COMPLETE MOTOR

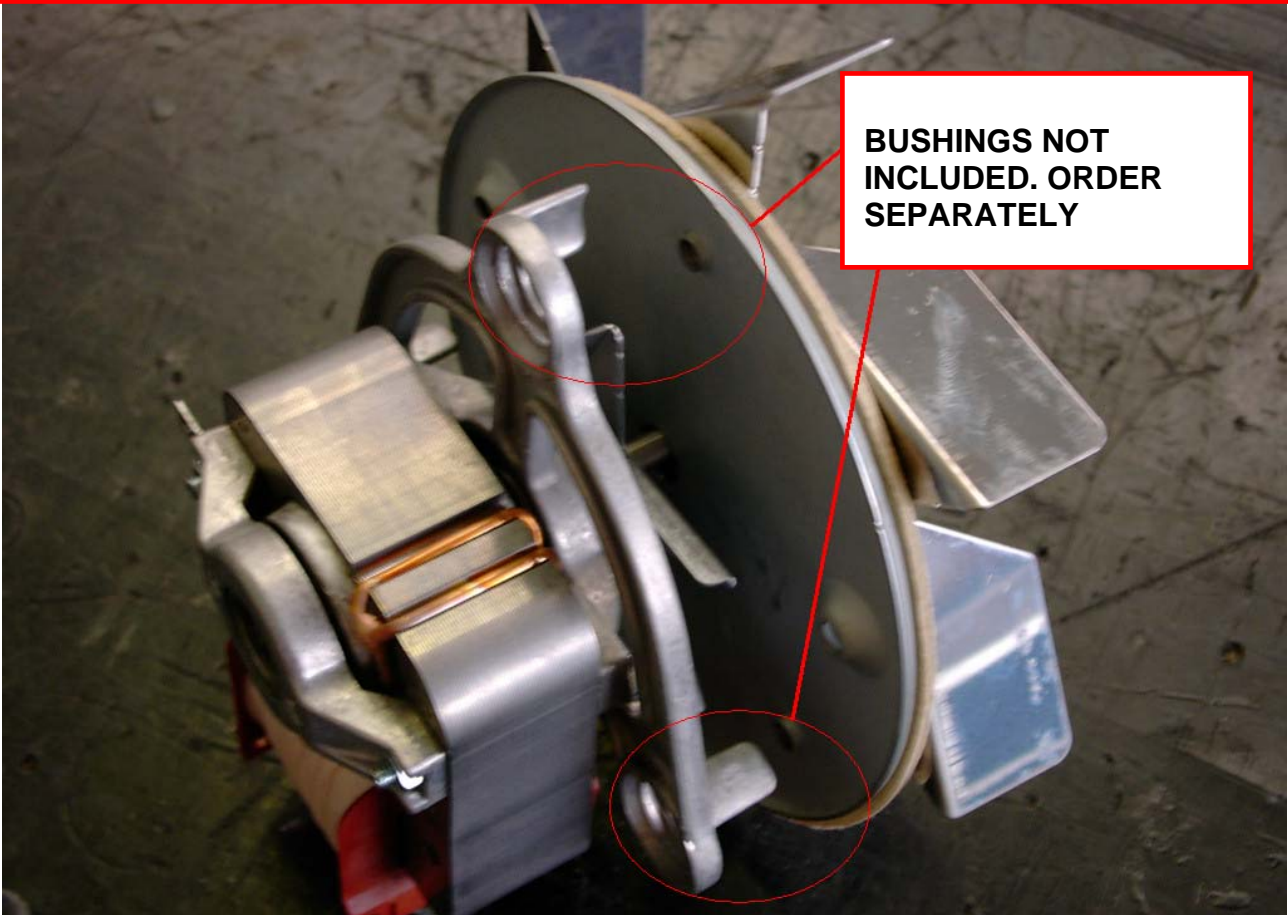
**MOTOR DELIVERED AS SPARES
PART MISSES THE HOLE TO FIX
FLANGE TO MOTOR BODY. ONLY
HOLES FOR OVEN FLANGE FIXING**

BUSHINGS TO FIX THE FLANGE ARE NOT INCLUDED IN THE SPARE PART CODE. ORDER 3 PIECES PARTNO. 180570136

**IF POSSIBLE, DISMANTLE THE ORIGINAL FLANGE AND MOUNT IT ON
THE NEW MOTOR, OTHERWISE DRILL OUT THE MISSING HOLE ON
THE NEW PART**
